SERVICE BULLETIN

NO: 10050402

Models: TXSR606/HTR960/HTR667/DTR5.9

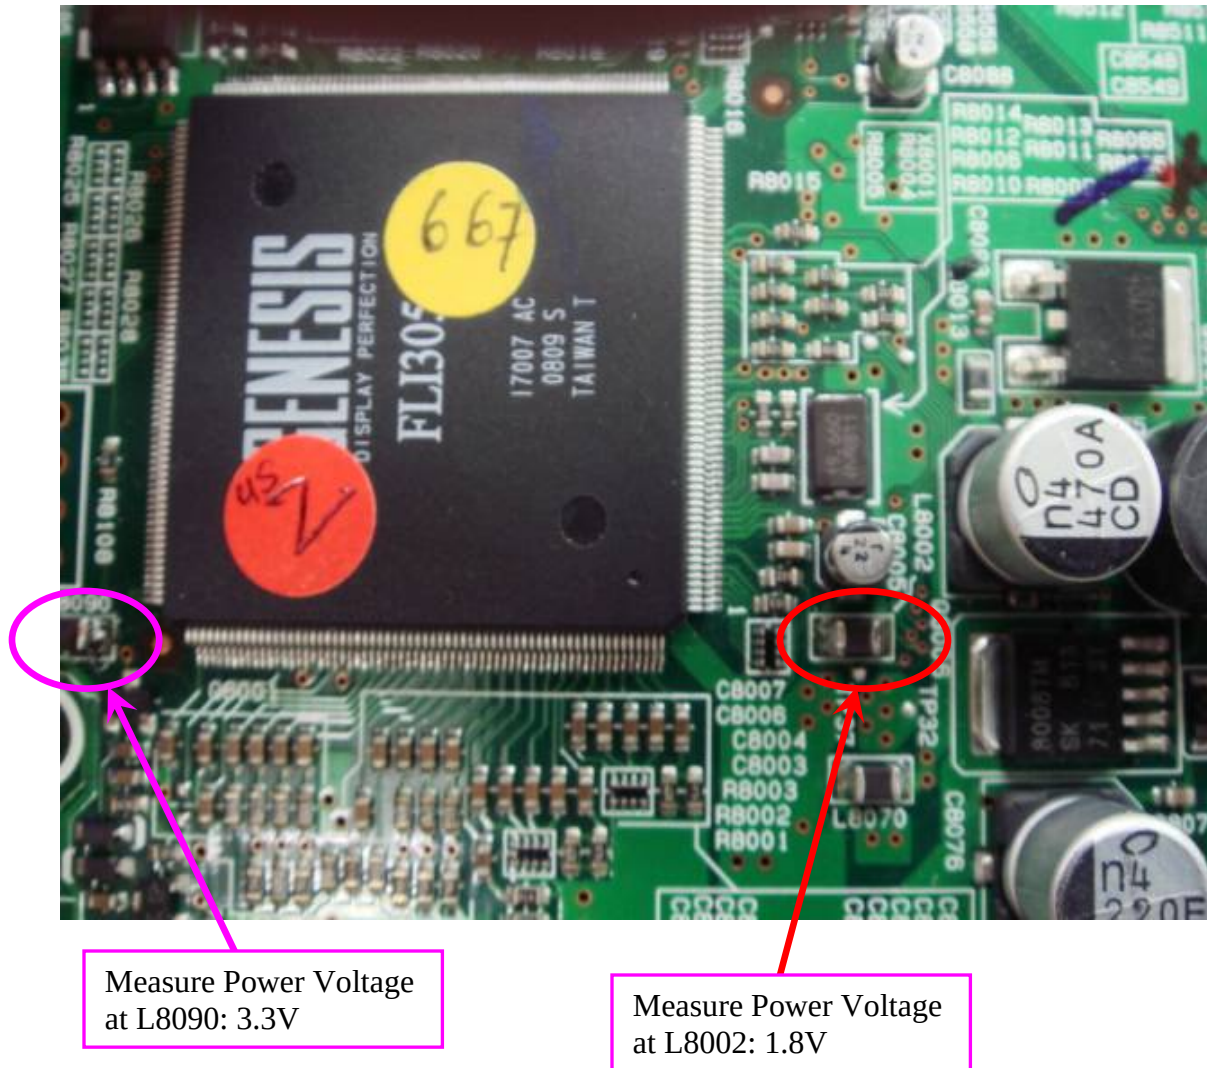
NOTE # 1: Before adding capacitor 104 between V.OUT and GND of Q8008, V.OUT and GND of Q8651 and V.OUT and GND of Q8654, make sure that Q8008/Q8651/Q8654 regulators are made by Toshiba. Do not add this capacitor, if regulators Q8008/Q8651/Q8654 are made by ROHM. To identify the maker of Q8008/Q8651/Q8654, read the print on the top surface of the regulator.
For Toshiba: Print will be “48018AF” or “48018BF”
For ROHM: Print will be “BA18BCO” (Please see notes on pages 4, 6 and 7)

Cause: Electric capacitors at output of three pin regulators on side B of HDMI pcb (bottom of HDMI pcb) deteriorate due to heat of power supply section. This results in three pin regulator output oscillations, which in turn causes malfunction in video signal processor.
Chip Capacitor C8096 (100uF/4V) on Side B deteriorates by heat from below
This causes Q8008 (1.8V) to oscillate and not to output 1.8V properly.
Sometimes, Q8005 (3.3) also oscillates and does not output 3.3V properly.

Measure voltages/waveforms at L8002 (1.8V) and then L8090 (3.3V) on side A (top side of HDMI board)

If the voltages/waveforms not right, then change following components, as shown below.

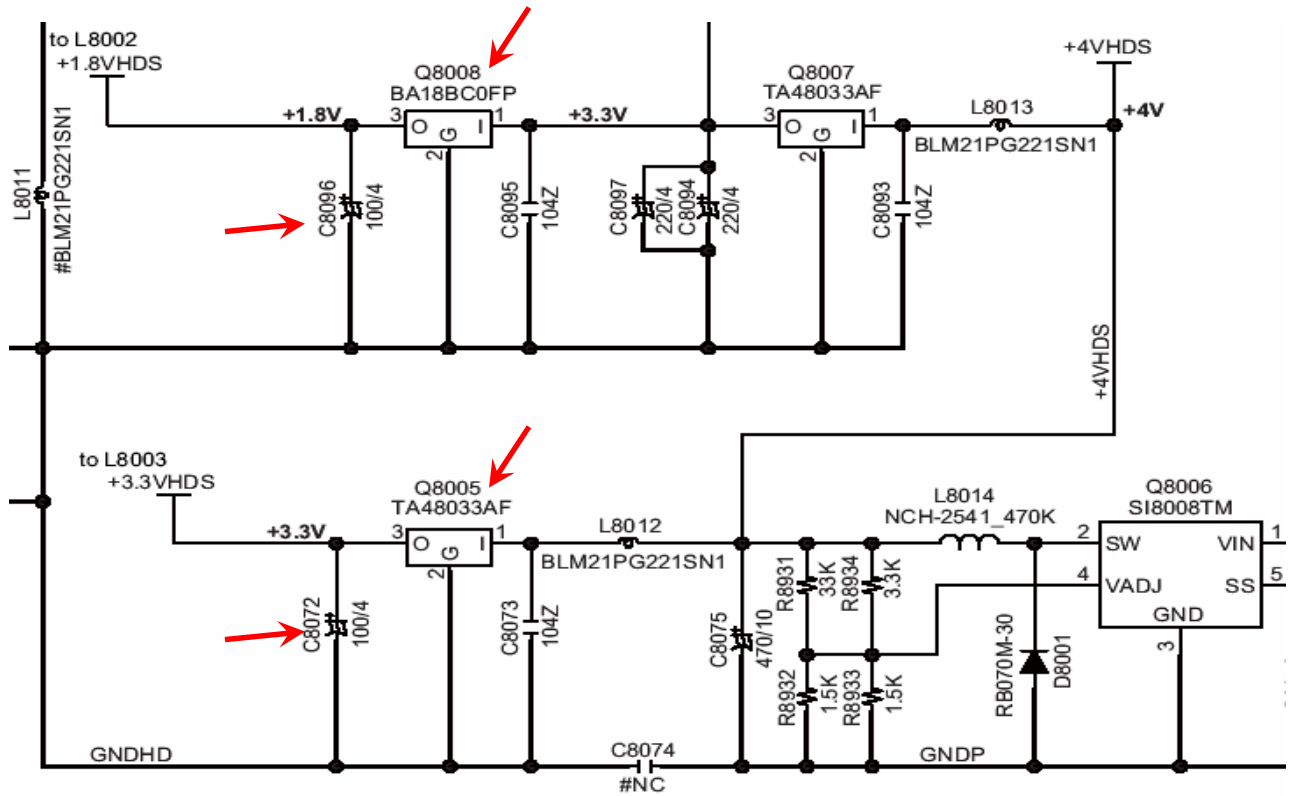
2. Replace Electric capacitor C8072 (100uF/4V) with a new one

Q8651	Toshiba make	ROHM Make
Add Capacitor	Yes	No

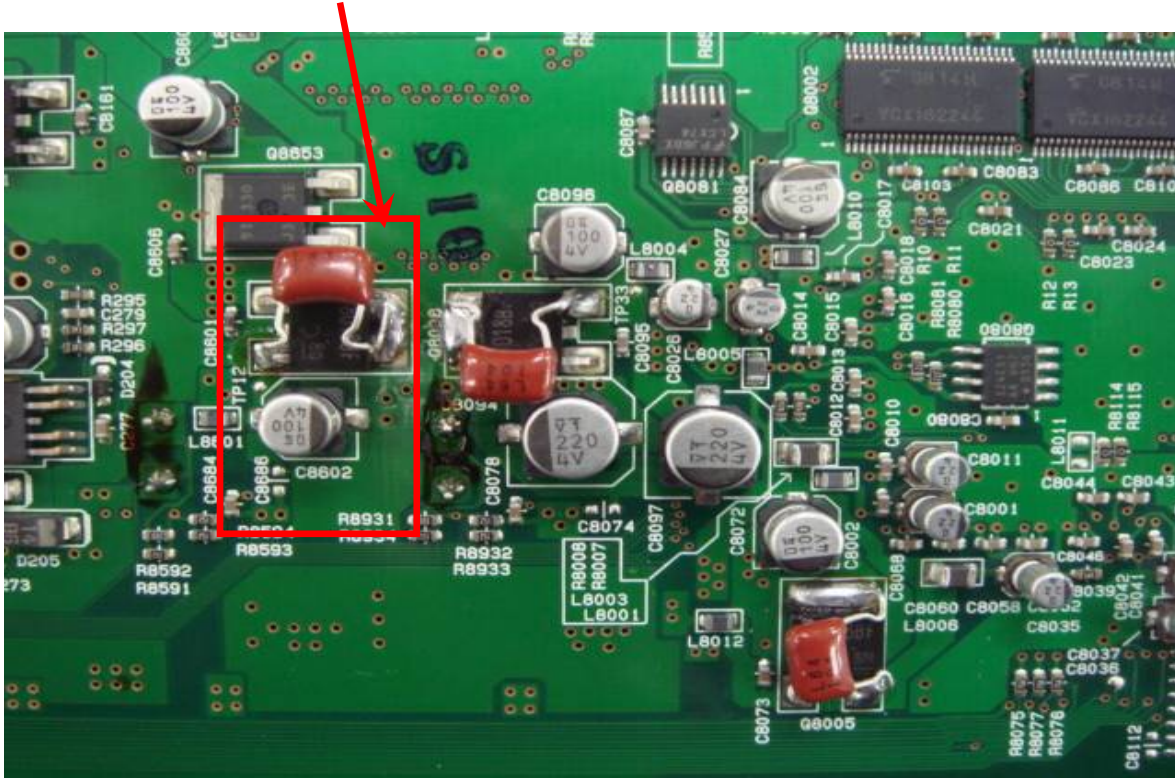
1. Add TF capacitor 104 between V.OUT and GND of Q8651 (1.8V) (as shown below).
Before adding this capacitor, make sure that Q8651 regulator is made by Toshiba. Do not add this capacitor, if the regulator Q8651 is made by ROHM. To identify the maker of Q8651, read the print on the regulator top surface.

2. Replace Electric capacitor C8602 (100uF/4V) with a new one

| Q8654 | Toshiba make | ROHM Make |

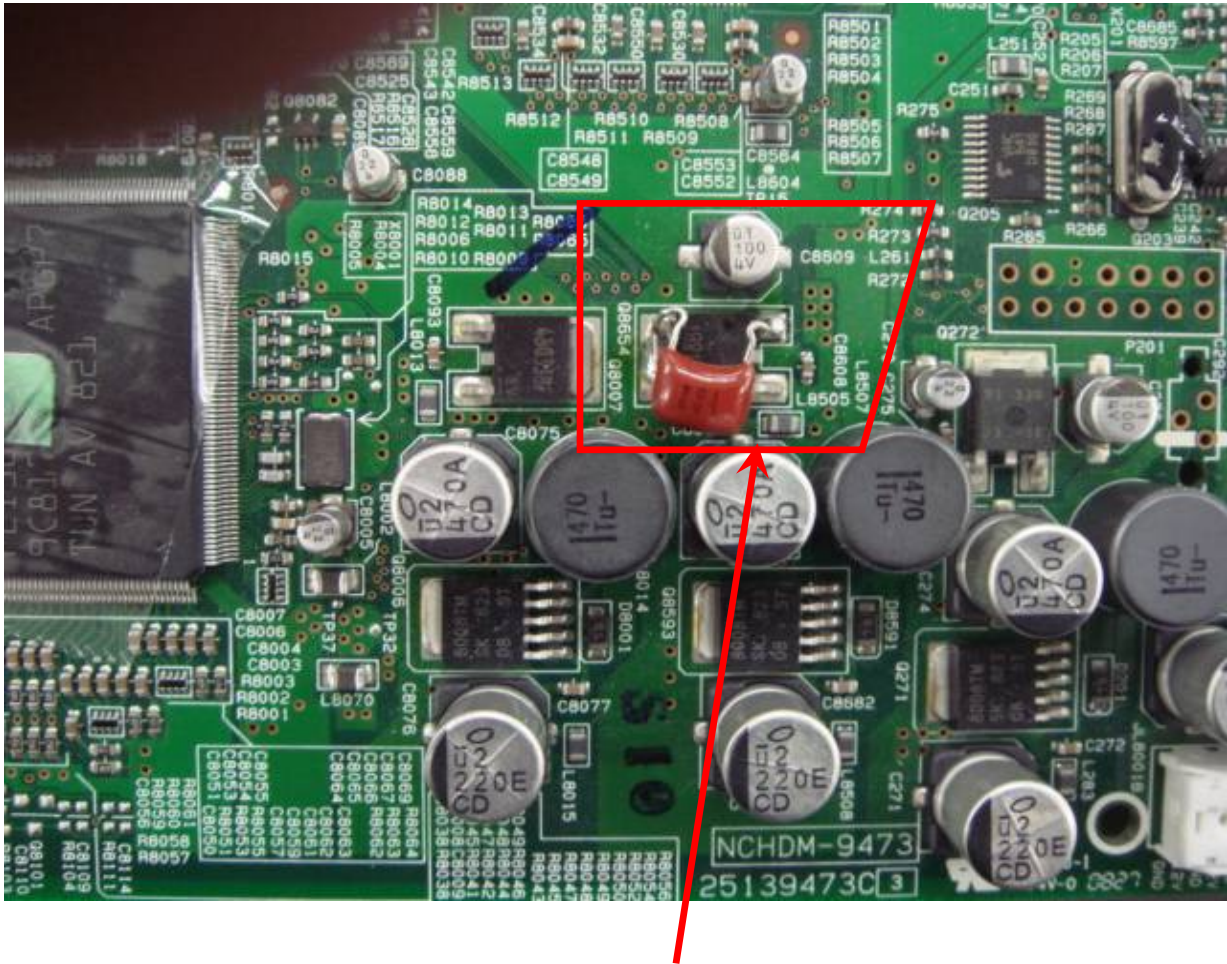
| Add Capacitor | Yes | No |
